**Motion #1: Adopting the Sept. 14, 2012 Draft ERC Regulating Plan with amendments as follows:**

**April 25, 2013 Approved Amendments to the Sept. 14, 2012 Draft ERC Regulating Plan**

**MARCH 7, 2013 SUMMARY SHEET****Approved Amendments to the Sept. 14, 2012 Draft ERC Regulating Plan****Council Action, Amendments, Group A:**

**Figure 1-5: East Riverside Corridor Collector Street Map**

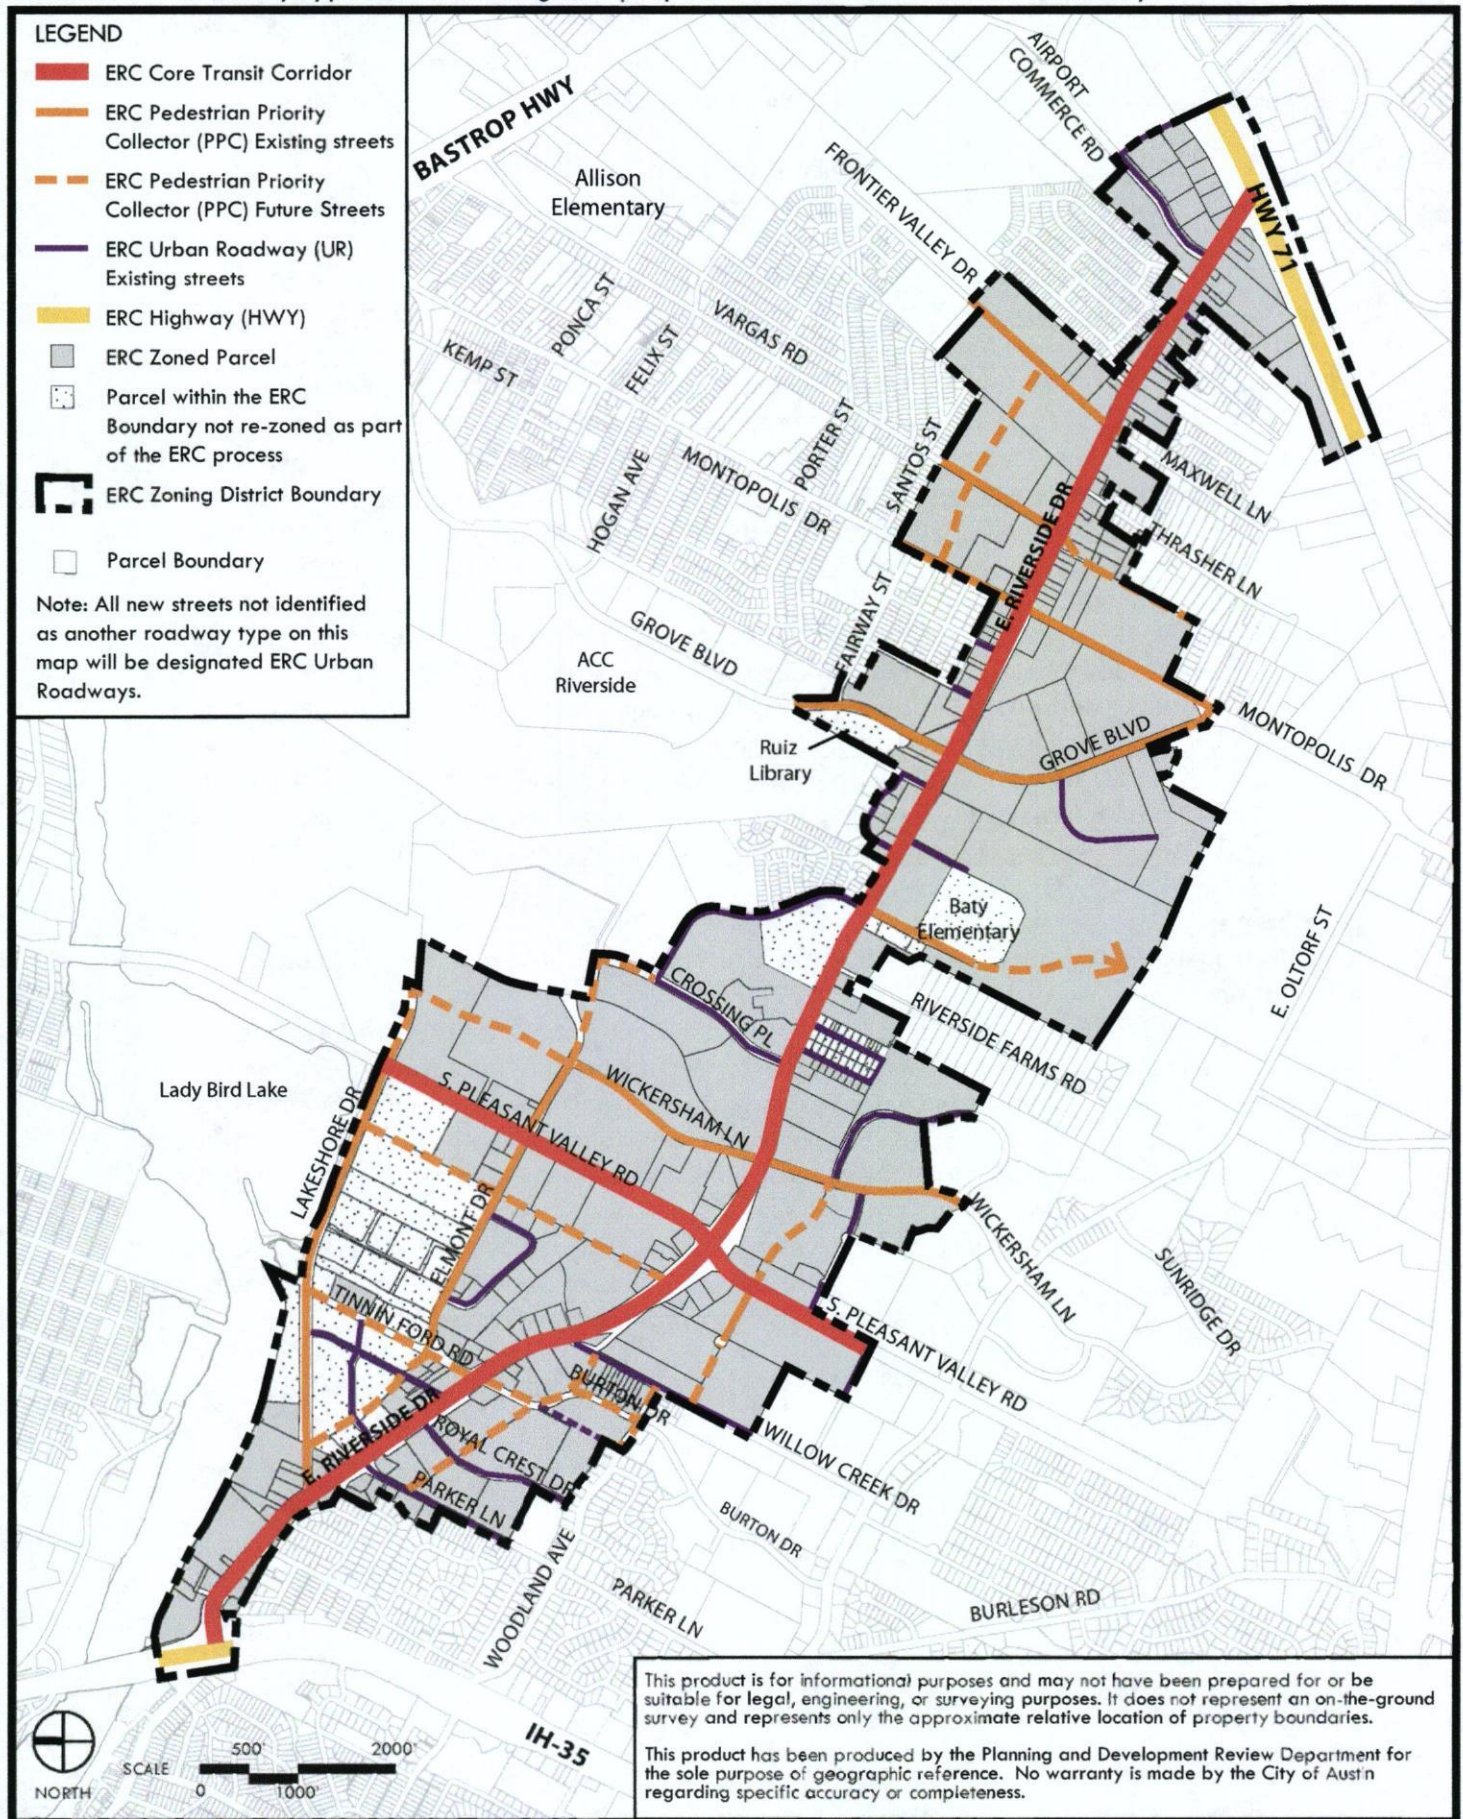
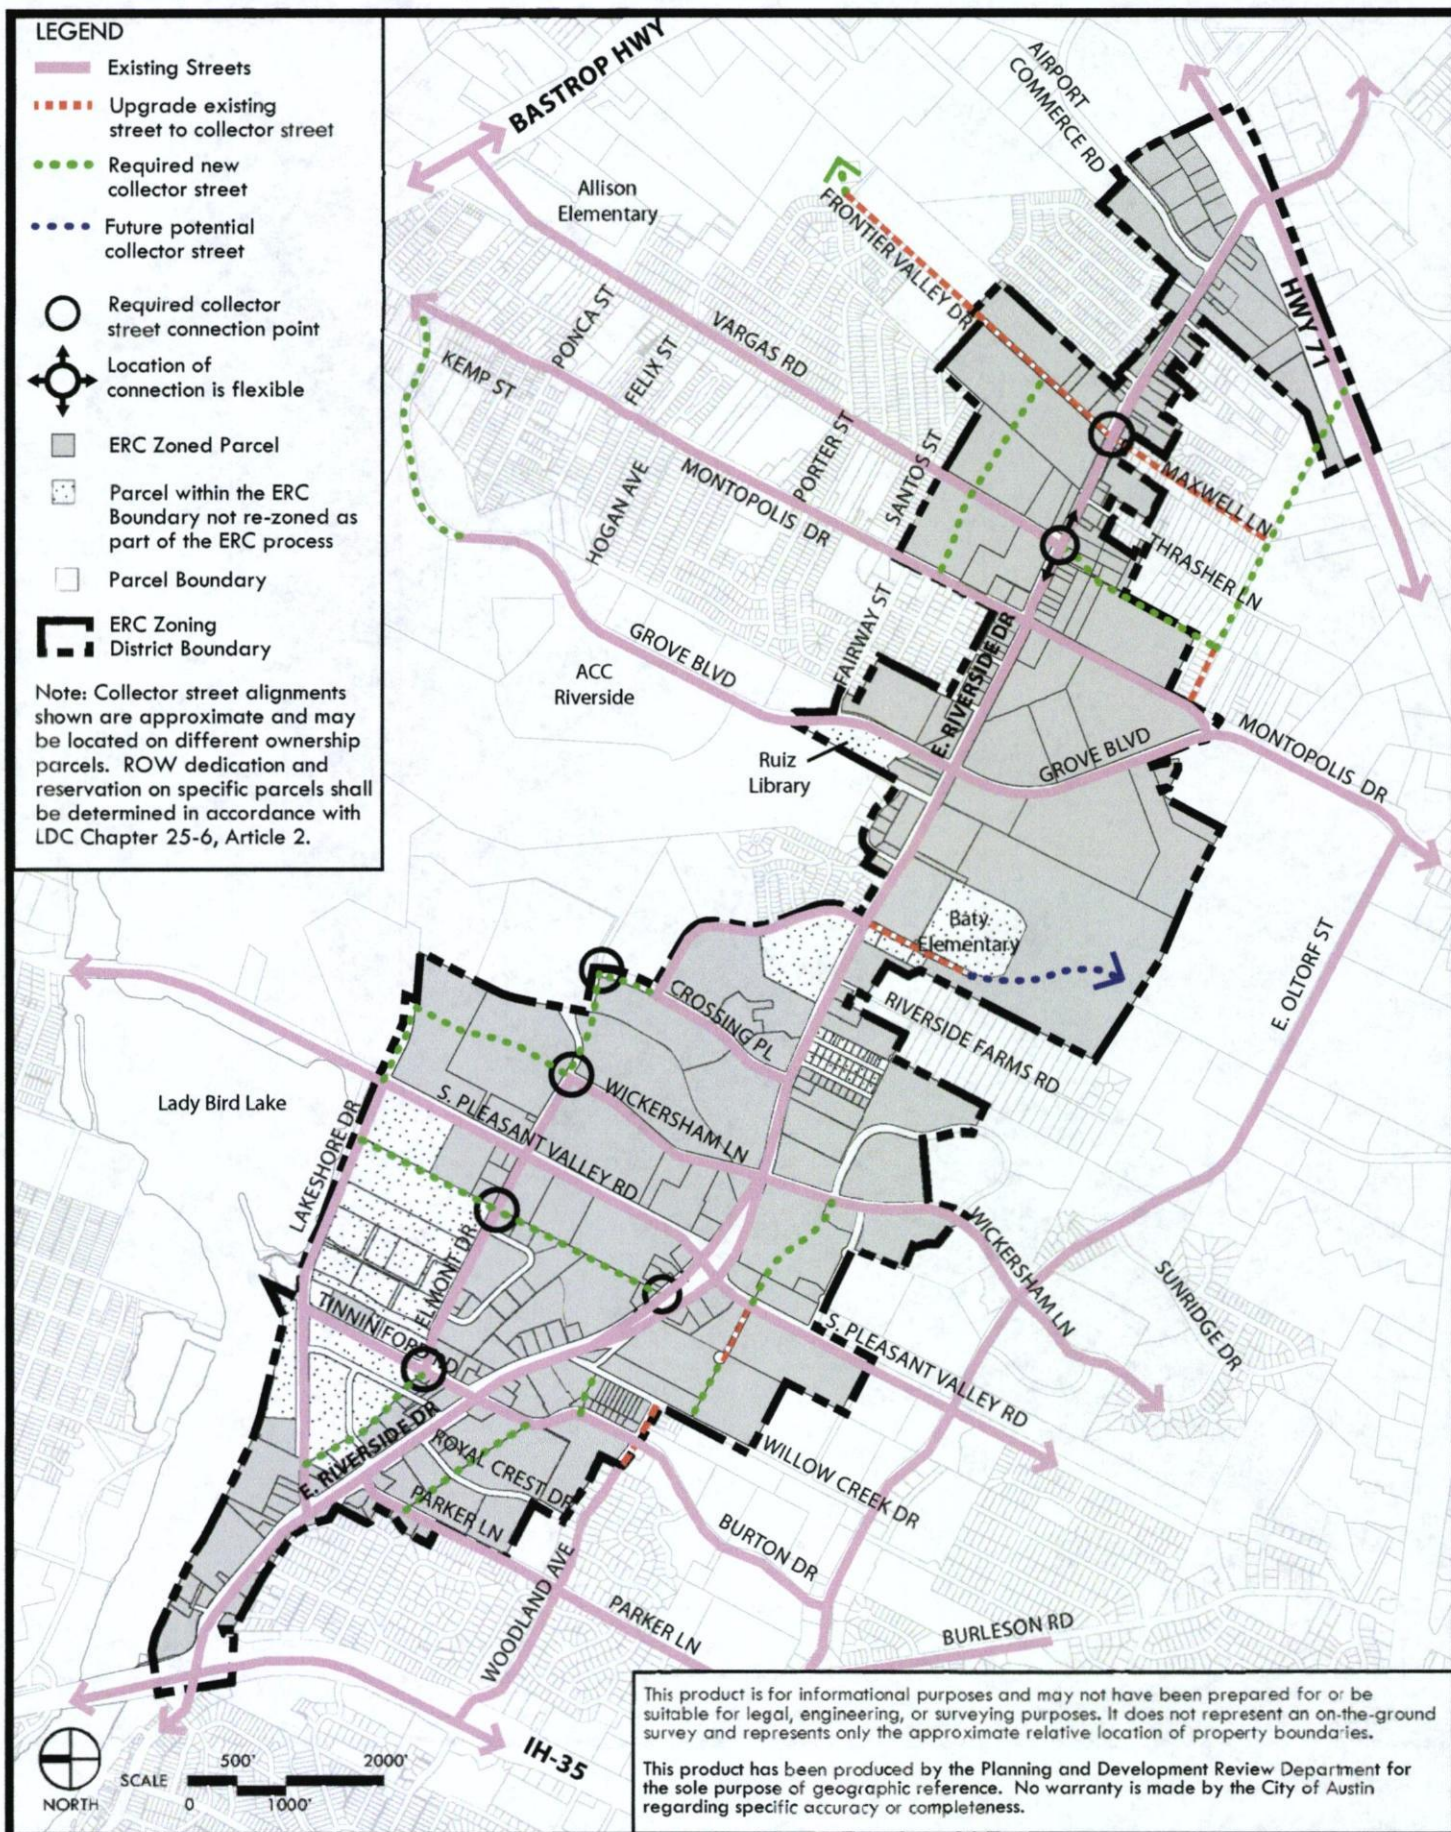
- C.2. P. 15, Modification to collector street map to account for an existing drainage way. See revised Figure 1-5: East Riverside Corridor Collector Street Map (Nov. 8, 2012 DRAFT – see attached) and associated Figure 1-3: East Riverside Corridor Roadway Type Map (Nov. 8, 2012 DRAFT– see attached).

# Figure 1-14: East Riverside Corridor (ERC) Future Land Use Map (FLUM)

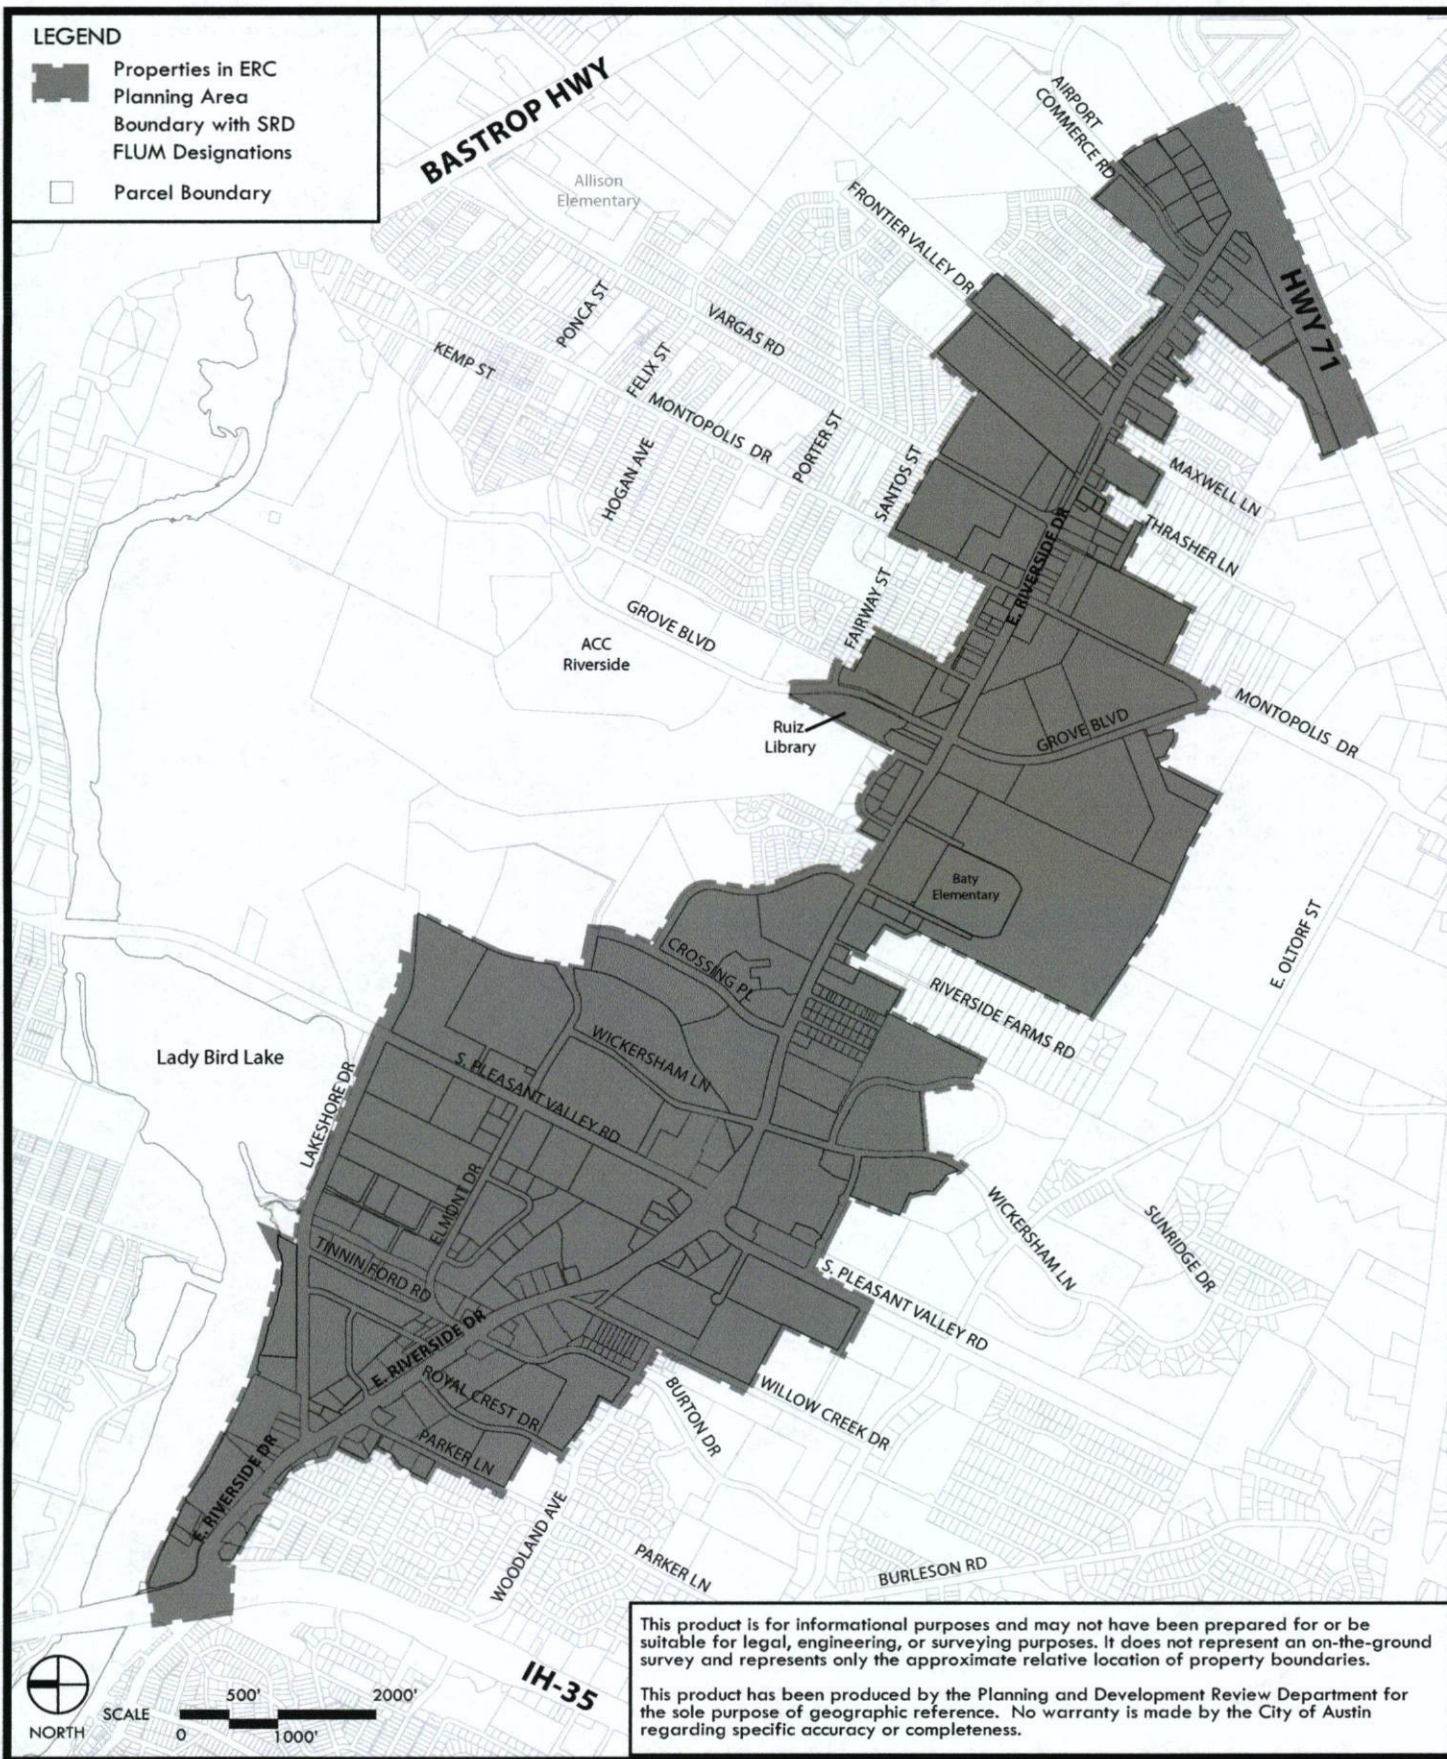
- A.3. P. 24. Add new Figure 1-14: East Riverside Corridor (ERC) Future Land Use Map (Nov. 8, 2012 DRAFT – see attached) (**Note:** Added for clarification purposes.)

**Figure 4-1: Two Story Minimum Requirements**

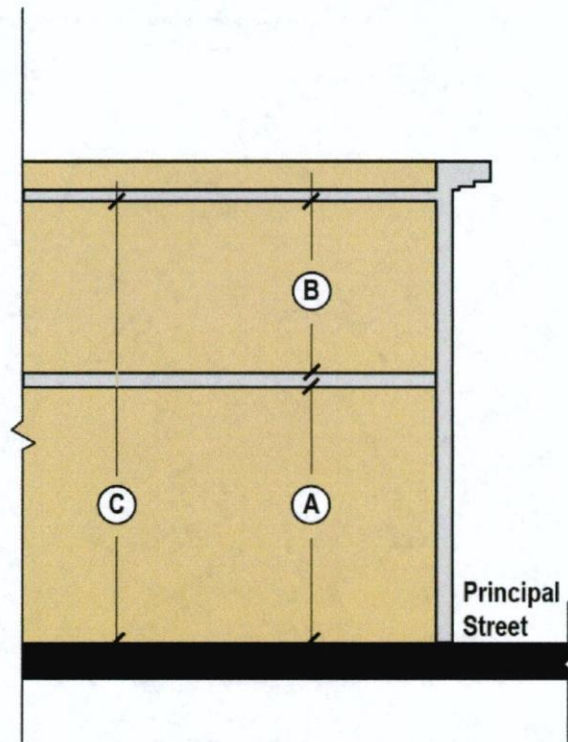
- A.5. P. 55, figure 4-1: Two Story Minimum Requirements. Replace figure with Nov. 8, 2012 Draft. (**Note:** Changed to make figure more understandable – see attached.)

**Figure 1-15: Map of Properties with Drive-Through Facilities as of [adoption date, 2013].**  
 Map of properties to which Subsection 2.3.5.B (Drive-Through Facilities) applies.

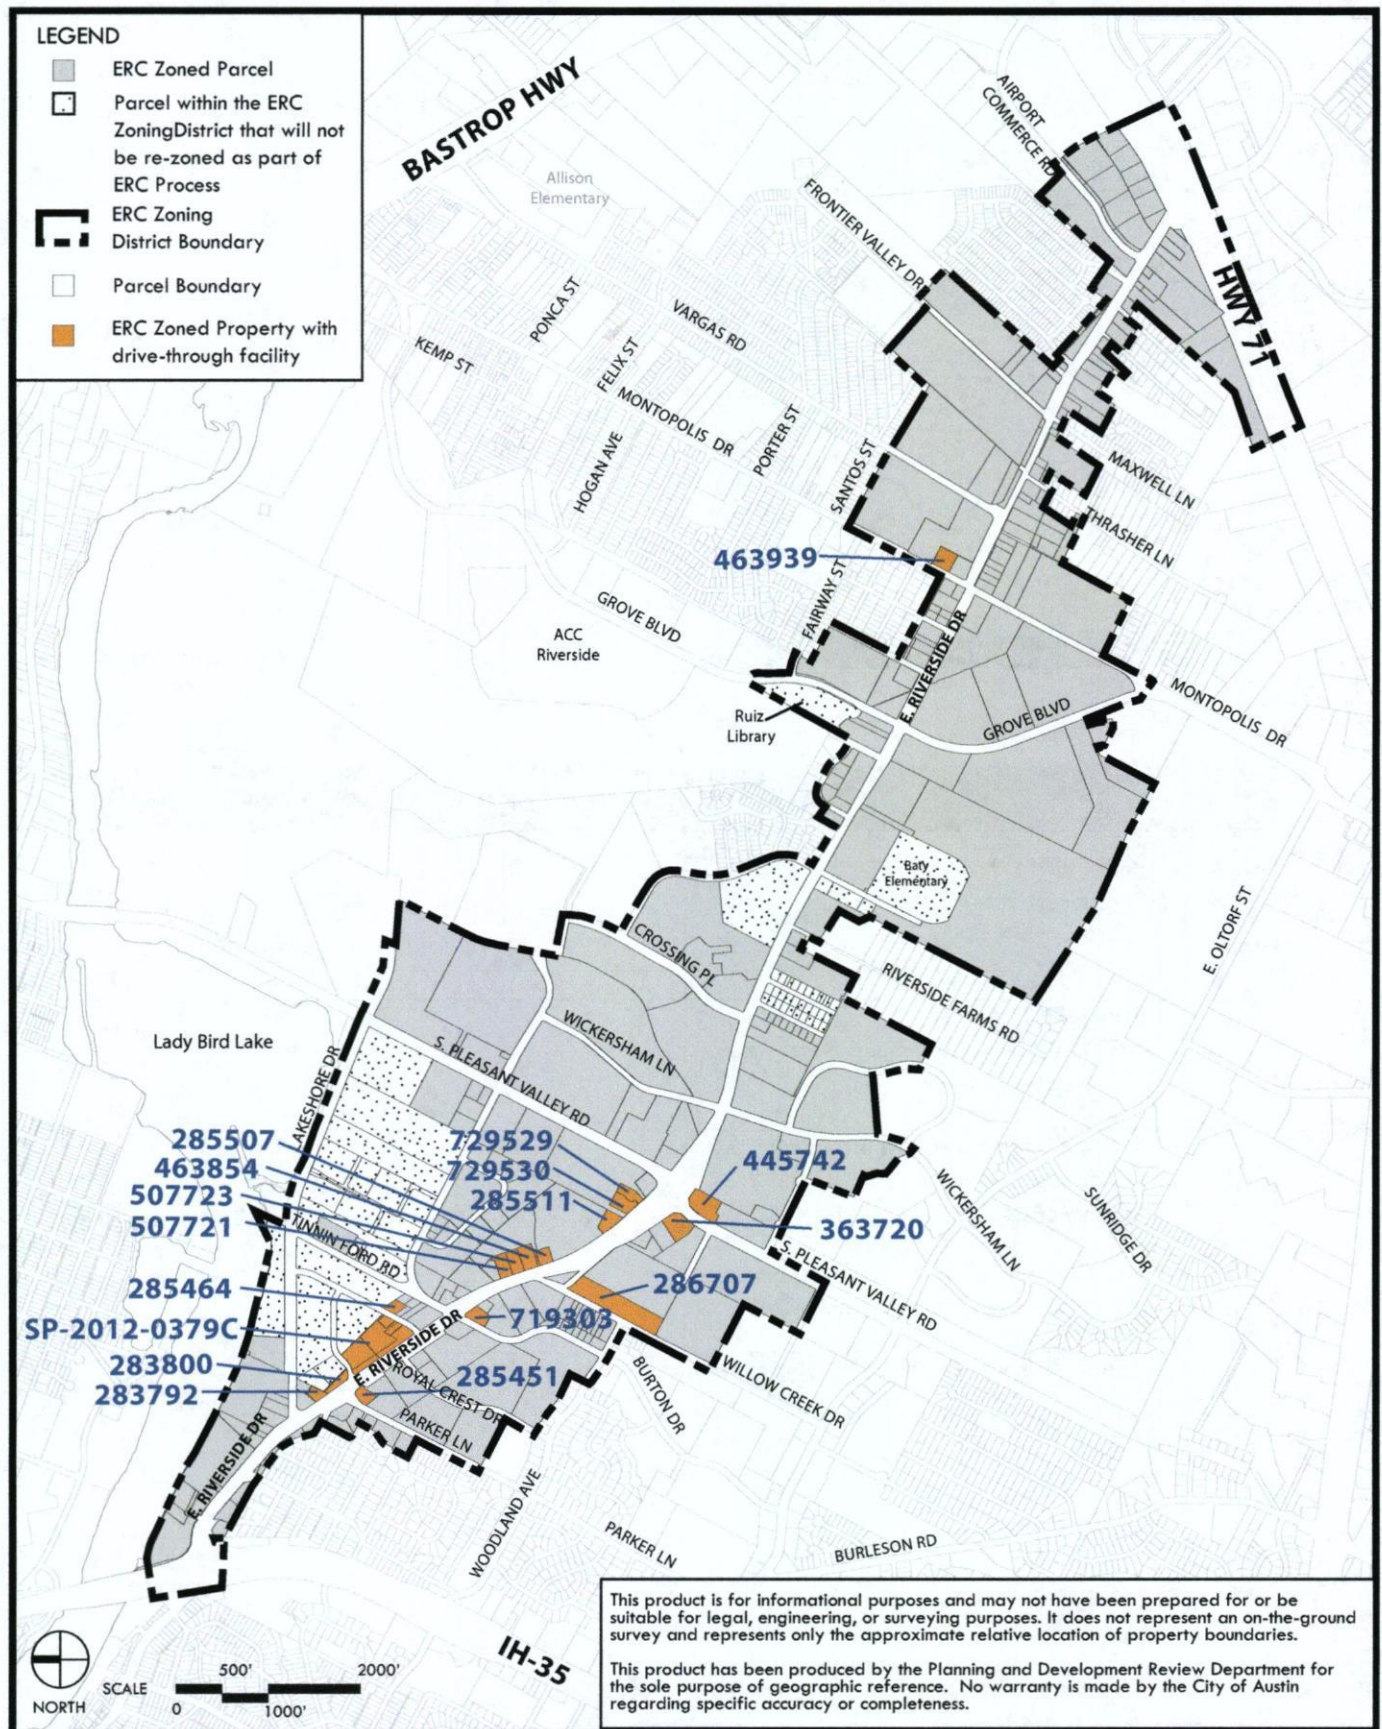
- D.1 P. 27, Subsection 2.3.5.B (Drive-Through Facilities) – Delete the text of Subsection B and replace with the following: “A property containing a drive-through facility legally constructed or permitted prior to [insert ERC Regulating Plan adoption date], is not subject to this Subsection 2.3.5.A. Construction on said properties can include the replacement of a drive-through facility, but construction will be subject to all standards in the ERC Regulating Plan according to the applicability standards in Section 1.2 Applicability. The number of drive-through bays or lanes cannot be increased from those existing as of the above date.” (**Note:** Staff deemed the original Subsection B language section repetitive and unnecessary.)
